Case Number: R18005

**CASE COMMENTS:**

Existing Stormwater Asset Map possibly affected by the Proposed Development

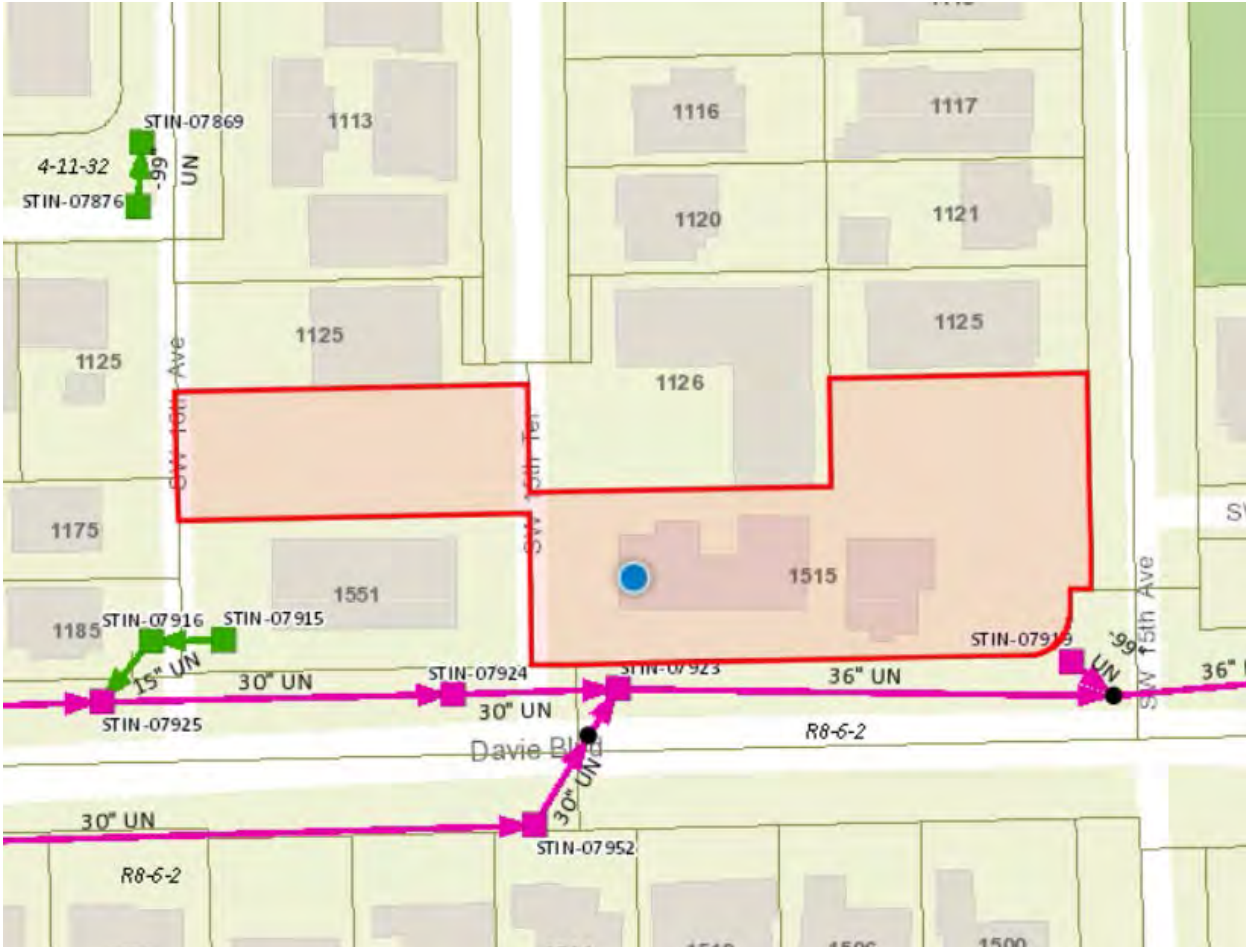
The City owns and maintains stormwater infrastructure adjacent to the proposed development as shown with green line work in the map provided at the end of this report. The following comments pertain to possible impacts of the proposed development and/or construction activities to the existing condition of the City's stormwater assets, including street swales. The applicant shall provide an itemized response letter addressing the following comments:

1. Please provide (or revise if already submitted) an erosion, sedimentation, and stormwater pollution prevention plan (**SWPPP**) showing the adjacent City's existing stormwater system as shown in the survey and to the limits shown with green line work in the storm map provided at the end of this report. A copy of the approved SWPP shall be at the construction site from the date of demolition initiation to the date of final construction activities.

- a) Contractor shall provide CCTV videotapes to City STW OPS of the existing stormwater system to the limits shown with green line work in the storm map provided at the end of this report in order to document the PRE and POST construction conditions of the City's storm system.
